PD Modification Application: MM 24-0368

AGENCY REVIEW COMMENT SHEET

PETITION NO: MM 24-0368

2.5 Proposed Site Plan (partial provided below for size and orientation purposes. See Section 8.2 for full site plan)

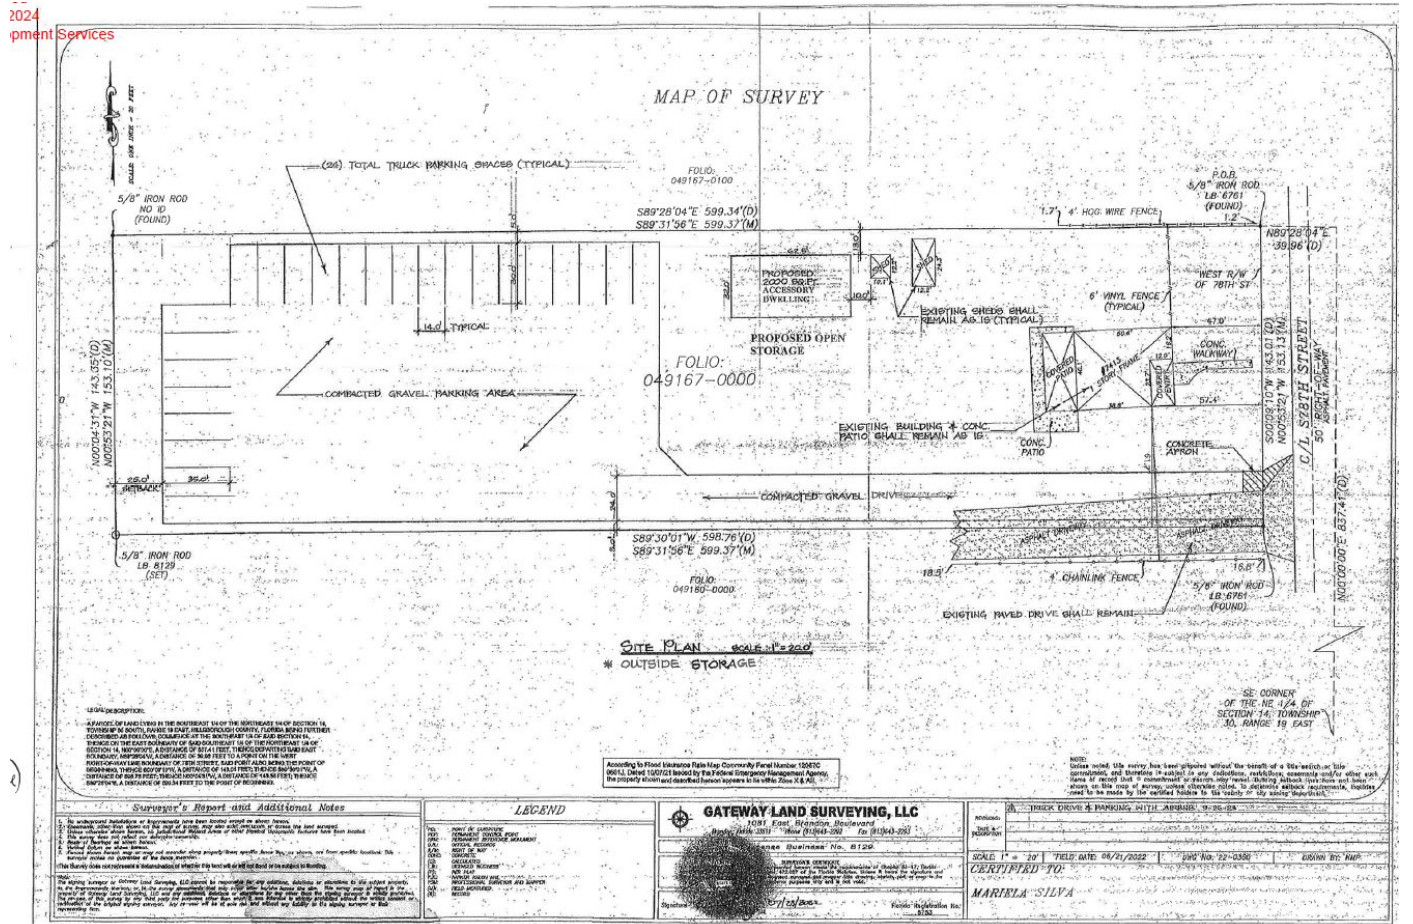
The proposed uses are compatible with the existing mining development to the east, and with a nearby couple of parcels zoned Manufacturing occupied with a junkyard and light industrial uses. However, staff has concerns with the proposed open storage use due to lack of proposed screening adjacent to residential uses within the PD, as outlined below.

Per LDC Sec. 6.06.06 Buffering and Screening requirements, a 30 feet wide buffer, type "C" screening is required to single family residential uses adjacent to the north and east. The applicant requested PD variations from these requirements; proposed a 5 feet wide buffer, with no screening to single family residential; and provided the following justifications: a) The existence of heavy commercial in the area, b) No one will be adversely affected. Staff finds those justifications are not supportable. No design efforts were provided to mitigate the adverse effects of the proposed use to the existing residential portion of the PD.

The proposed accessory dwelling exceeds the maximum size for accessory dwellings as provided for in LDC Section 6.11.02.

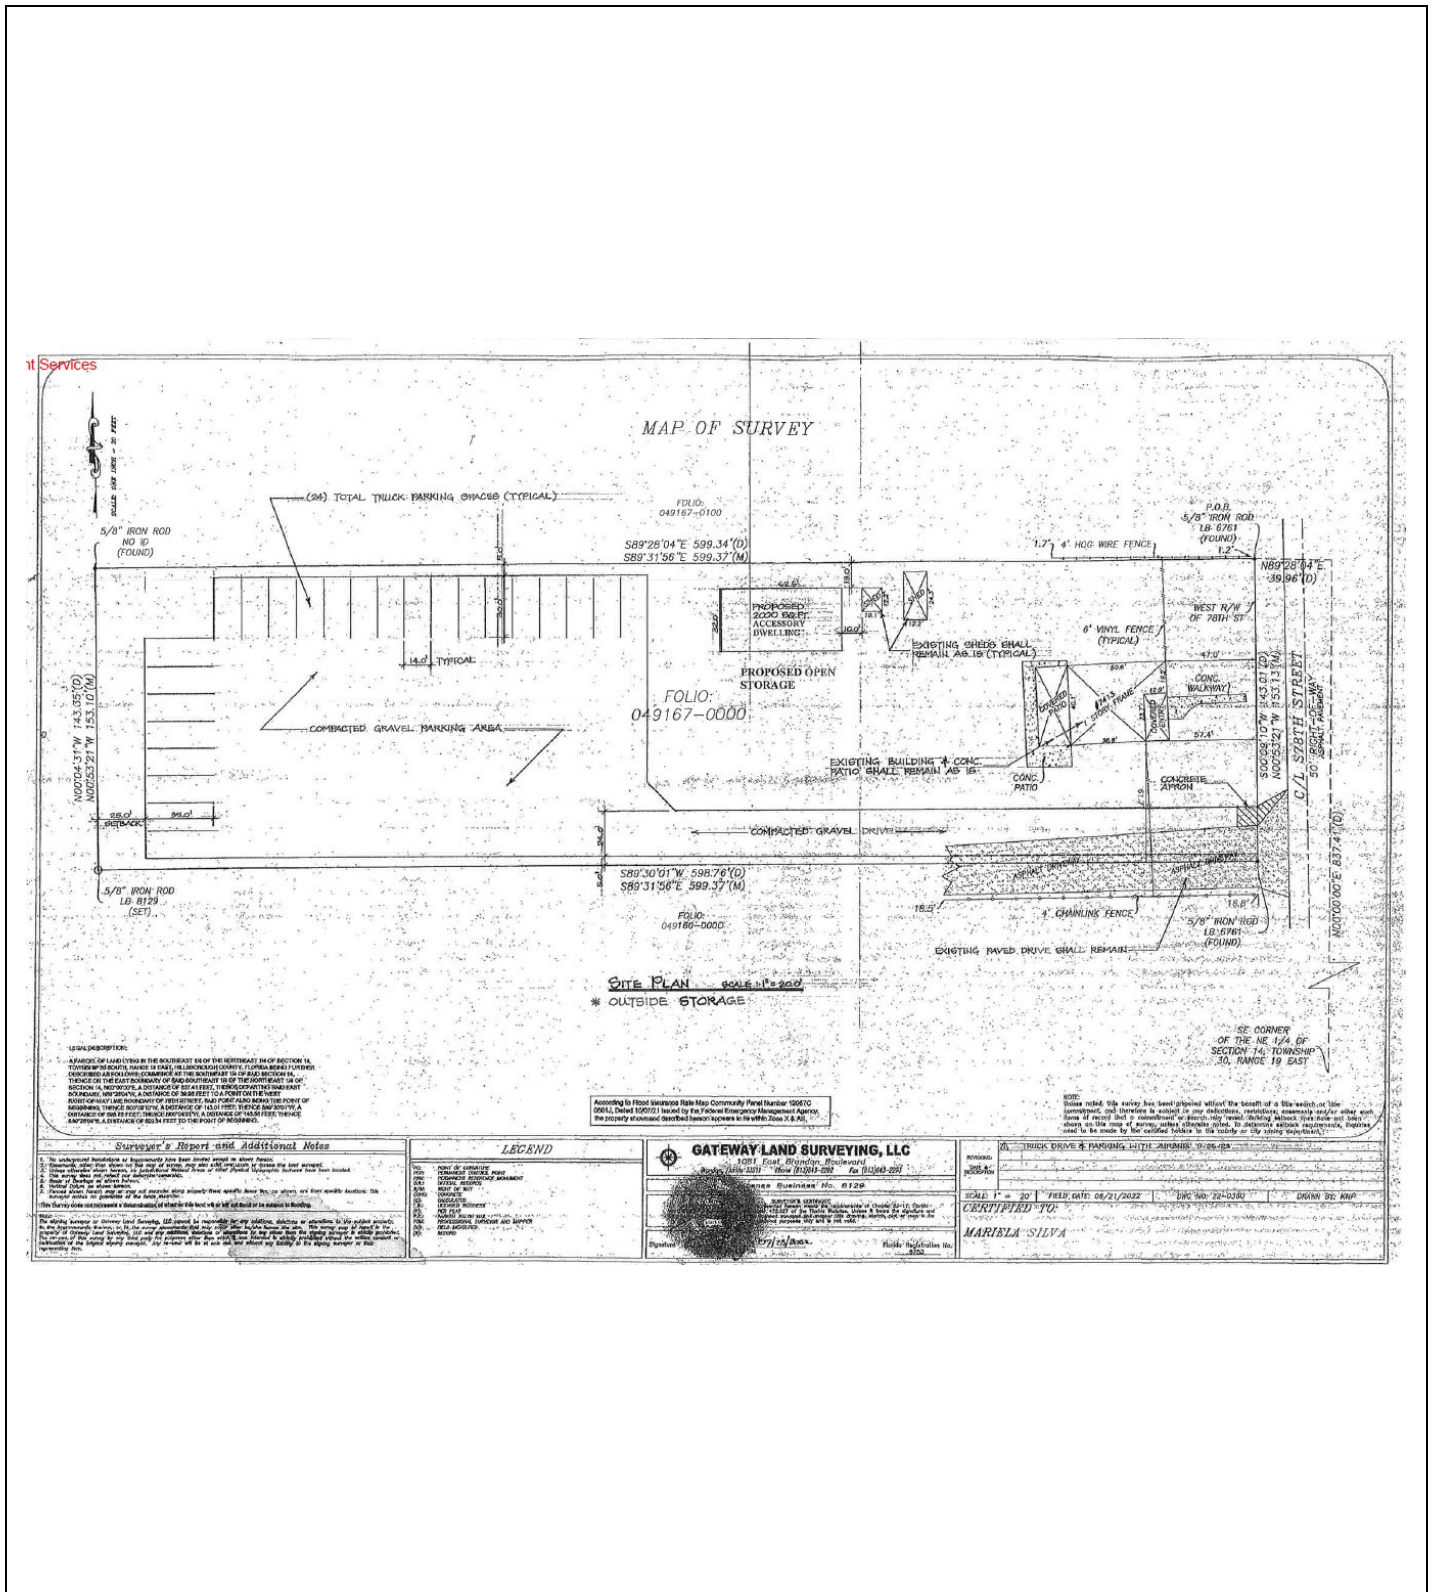
2. The existing driveway serving the site appears to be encroaching into land owned by Mosaic to the south. Additionally, that PD zoning does not authorize a connection to 78th St., and therefore no connections from the Mosaic property can be permitted. Staff advised that if the applicant had been claiming an easement, per the DRPM all easements within and adjacent to the site must be shown and labeled; however, easements cannot violate the terms of PD zoning conditions. Staff advised the applicant to shift the proposed access to the north (such that it occurred wholly within the subject PD); however, no site plan revisions were received.

3. The applicant is proposing a commercial use on the same parcel as a single-family detached dwelling unit. Given Sec. 6.04.03.O. and other access management requirements within the Hillsborough County Land Development Code (LDC), these uses cannot share a single access unless certain conditions are proposed or agreed to by the applicant. Staff reviewed these options with the applicant; however, no revised information or commitments were received that would otherwise address this issue.

4. Given that PD site plans are by their nature binding commitments with limited flexibility for changes absent a zoning modification, staff advised the applicant that it was strongly recommended that they file a “bubble” type plan which would provide additional flexibility for the developer in the future and at the time of site/construction plan review. Staff informed the applicant that absent such a revision to the site plan, the applicant would need to revise the detailed plan to comply with applicable Transportation Technical Manual (TTM), LDC, and other applicable requirements. Staff notes that the existing plan shows a variety of elements and features which violate these requirements and would not be permitted at the time of site/construction plan review. Staff notes that no revisions were received to the site.

5. Staff advised the applicant that all use/material references needed to be removed from the PD site plan, and that if the applicant desires to utilize an alternative material for drive aisles and/or parking areas, then the applicant must submit a PD Variation request for each. Staff also noted

6. S. 78th St., along the project's frontage, is shown on a Hillsborough County Corridor Preservation Plan as a future 4-lane roadway. The amount of right-of-way to be preserved is based upon the existing available right-of-way and the Transportation Technical Manual (TTM). The applicant was advised that (per the DRPM) they are required to show the entire available right-of-way along both sides of the roadway and sufficient detail to demonstrate on what basis the amount of proposed right-of-way preservation was based. Staff advised the applicant that they believed that 10 feet of right-of-way preservation is required based on preliminary data; however, the final amount would be determined based on more detailed data required to be submitted by the applicant. In making its preliminary findings, staff examined the available right-of-way in the area and noted that along the project's frontage, there is less right-of-way available than the area just to the south of the project. Staff determined that the prevailing right-of-way acquisition pattern along the east side should be applied further to the north, and so extended that future line north. The preservation amount was tentatively calculated by obtained the existing/assumed right-of-way width with that adjustment made, as measured just south of the proposed project, which measured +/- 90 feet. Staff notes that per Typical Section -6 (TS-6) of the TTM, which is for 4-lane urban roadways), a minimum of 110-feet of right-of-way is needed. The applicant's responsibility per Sec. 5.11 of the LDC is for 1/2 of the needed additional right-of-way, or 10 feet ($110 - 90 = 20$. 20 divided by $2 = 10$). This calculation was required to be explained in the project narrative and preservation labeled on the site plan in accordance with the DRPM. The applicant did not provide a revised narrative or show required right-of-way preservation on the PD site plan.

7. The applicant was required to demonstrate compliance with minimum throat depth standards. They applicant was advised that if the applicant desires relief from these requirements, then a Sec. 6.04.02.B Administrative Variance must be submitted. Staff advised that throat depth to the first gate is measured from the edge of the future closest through lane (which is 22-feet from the edge of the future right-of-way line per TS-6). As such, a project with a 50-foot minimum required throat depth would be required to ensure the first gate is no closer than 28 feet from the edge of the preserved right-of-way line. The applicant was requested to show measurements accordingly (and adjust if necessary). No such revisions or additional information were received.
